Greenwood Phinney Park Development

Meeting Summary

This was the Seattle Design Commission's (SDC) third review of the Greenwood Phinney Park Development project. The purpose of this meeting was to review the design development phase of the project. After the presentation, questions, and deliberation, the SDC voted, 8-0, to approve the design development phase of the Greenwood Phinney Park Development with several recommendations

Design Development

Figure 3: Previous design proposal (top) and updated design proposal (bottom)

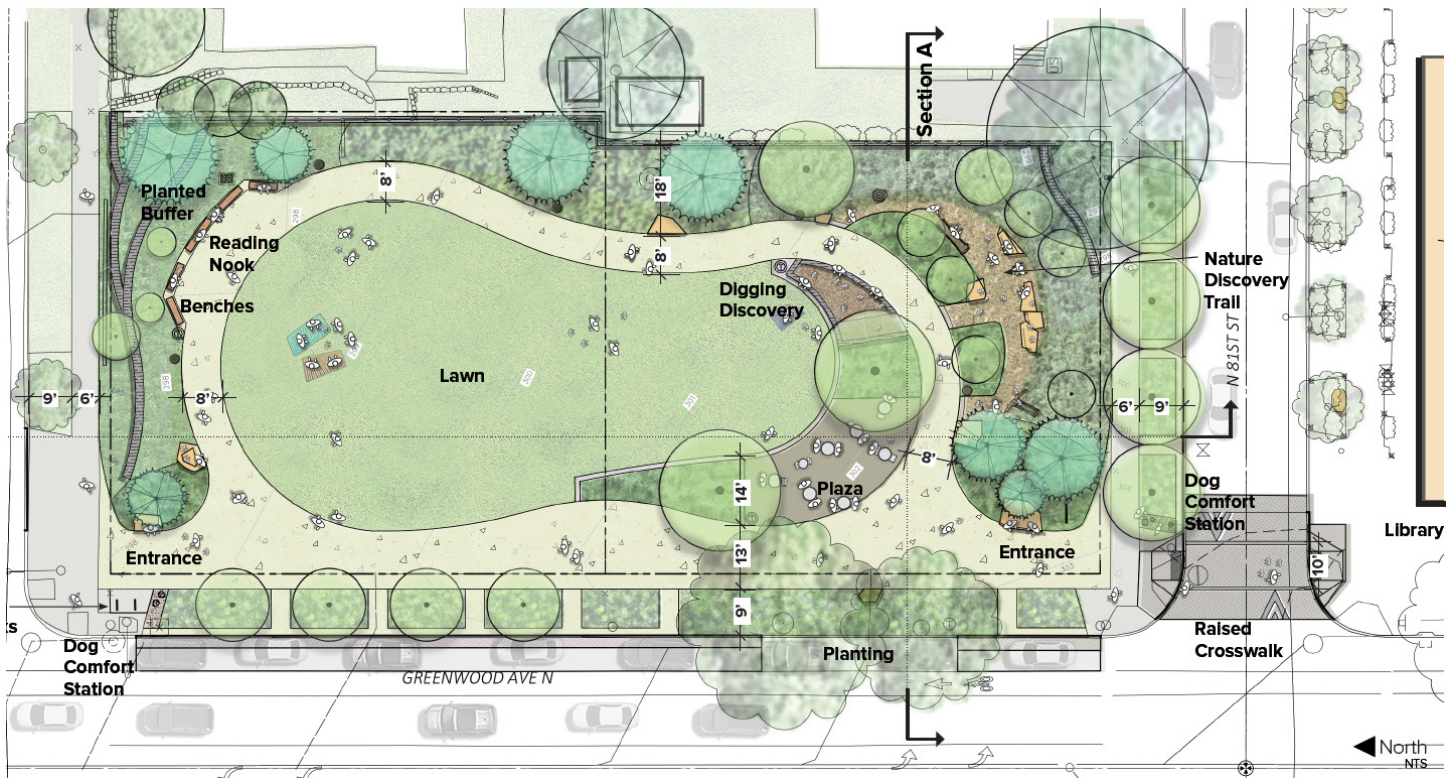
The SDC acknowledged the positive changes made to the design proposal. Commissioners agreed the updated design provided connectivity throughout the park. The commission then commended the design team for the further integration of the plaza and sidewalk. Several commissioners encouraged the project team to include a small reading area within the natural discovery area, while other commissioners acknowledged park users would already be able to read anywhere throughout the park.

Figure 4: Proposed landscape design

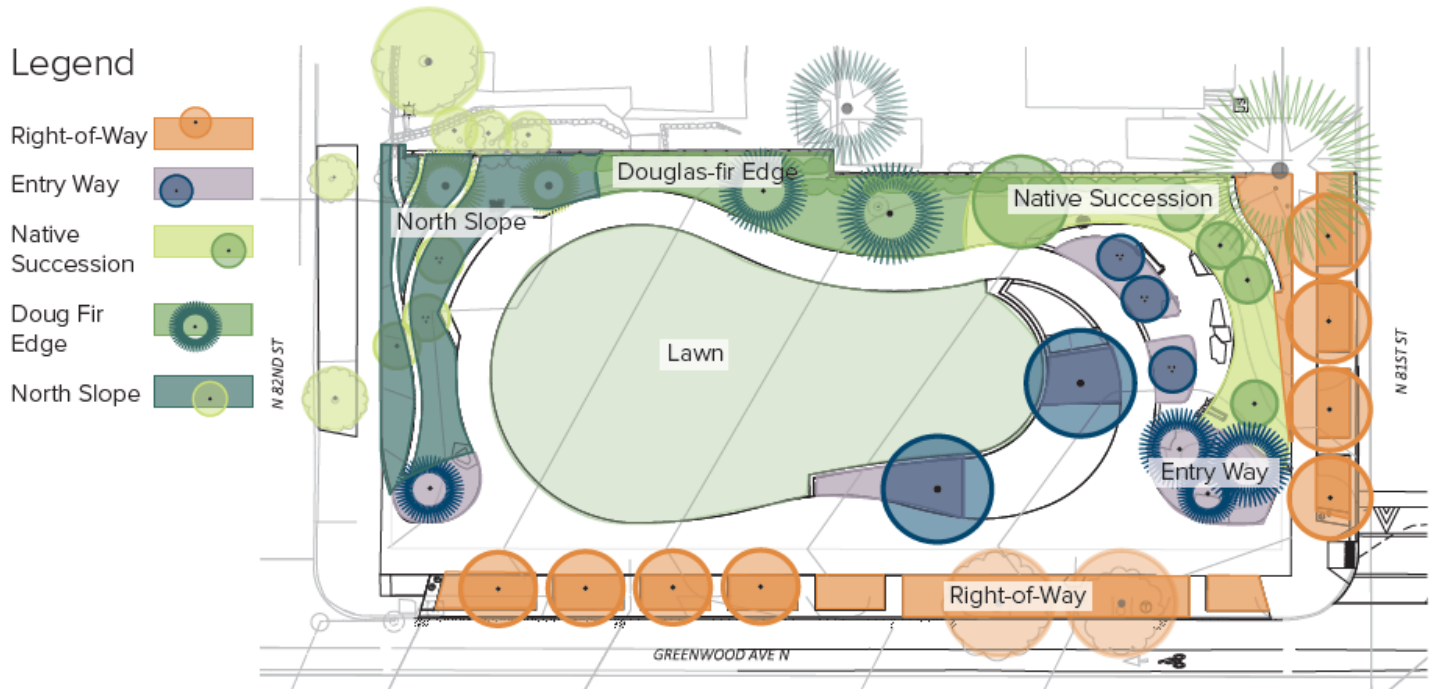
The SDC questioned the importance of representing different landscape zones throughout the park. Given the small size of the park and proposed zone areas, commissioners are concerned the landscape zones will blend together. The commission recommended adding small signs, identifying the plant botanical name, for small number of plants throughout the park.
